UNITED STATES PATENT AND TRADEMARK OFFICE

APPLICATION NO.	FILING DATE	FIRST NAMED INVENTOR	ATTORNEY DOCKET NO.	CONFIRMATION NO.
10/538,487	06/08/2005	Edmund W.M. Poh	A1-231 US	2274
23683 7590 03/14/2007 MOLEX INCORPORATED 2222 WELLINGTON COURT LISLE, IL 60532			EXAMINER LE, THANH TAM T	
			ART UNIT	PAPER NUMBER
			2839	
SHORTENED STATUTORY PERIOD OF RESPONSE		MAIL DATE	DELIVERY MODE	
3 MONTHS		03/14/2007	PAPER

Office Action Summary

DETAILED ACTION

FIGURE A

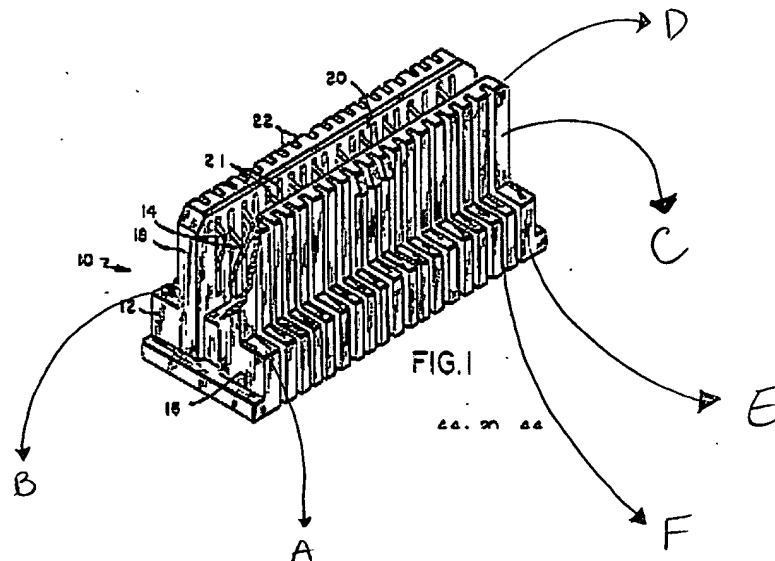
Regarding claims 1, 17 and 19-21, Classon et al., figure 1 shows a connector comprising:

- a housing (10) including a first housing base wall (A) and a second housing base wall (B) connected to the first housing base wall and spaced therefrom, the first and the second housing base walls each having an inner side and an outer side, opposite side, the inner side of the first housing base wall facing the inner side of the second housing base wall, a plurality of ribs (C)

- extending from the first and second housing base walls and spaced apart from each other such that a slot (21) is defined between adjacent ribs, each rib including a first rib portion extending from the first housing base wall in a first direction and a first rib portion extending from the second housing base wall in the first direction such that each slot has a first slot portion (D) which is open to the outer sides of the first and second housing base walls, and a second rib portion (E) extending from the first housing base wall in a second, opposite direction, and a second rib portion extending from the second housing base wall in the second direction such that the each slot has a second slot portion (F); and

- at least one terminal (14) positioned within the each slot and connected to the housing such that a surface area of the at least one terminal is exposed to the environment and air can flow over the surface area to dissipate heat from the at least one terminal.

Regarding claim 2, the at least one terminal is positioned within a respective first slot portion and second slot portion.

Regarding claim 18, the first direction is a direction away from the circuit substrate.
